*Re: Design Exception #23-07 – PP-2007-227*

## DESIGN EXCEPTION REQUEST 23-07

Project: Shetland Meadows Subdivision

City File Number (If Applicable) PP-2007-227

Plan "A"

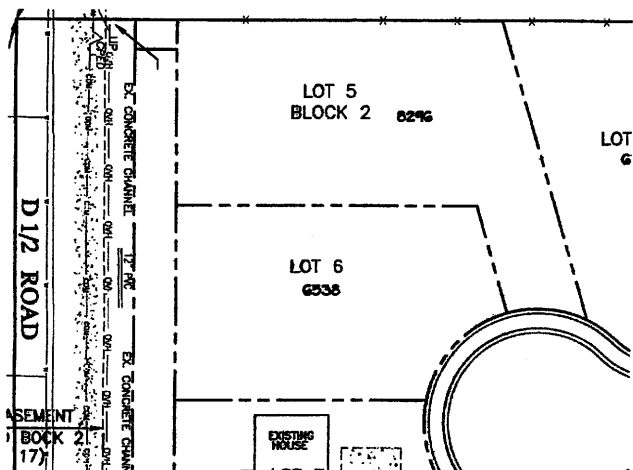
The petitioner requests that lot 4 be allowed to driveway access to the cul-de-sac, and not be required to use the shared drive. Lot 4 would not be required to be an owner of the shared drive.

The preferred layout (above) shows lots 4, 5, and 6 abutting the proposed shared drive. Per code section 6.7.D.6, no more than 4 dwelling units may share a single driveway access to a public street. TEDS also states that no more than four lots shall abut or touch any portion of the shared driveway (13.2.1.2)

Granting this application would allow the removal of the existing driveway connection from D-1/2 Road to the Capps property if or when the property is subdivided. Granting this application allows the petitioner to comply with the wishes of the Planning Staff without losing a residential lot if a full right-of-way were to be extended to this .8 acre site.

Not granting this application would restrict the number of lots accessible from this shared drive to four. The Capps lot access would be restricted to a single home site.

Not granting this exception would allow the petitioner to eliminate the shared drive and access lot 5 using a flag lot (Code section 6.7.D.2).

TO CLARIFY

- LOT 4 DOES NOT HAVE TO OWN OR ACCESS SHARED DRIVE
- LOTS 2, 6, & TWO "CAPPS" LOTS WILL ACCESS THE SHARED DRIVE.
- THE SHARED DRIVE MUST BE BUILT TO THE SUBDIVISION PROPERTY LINE.
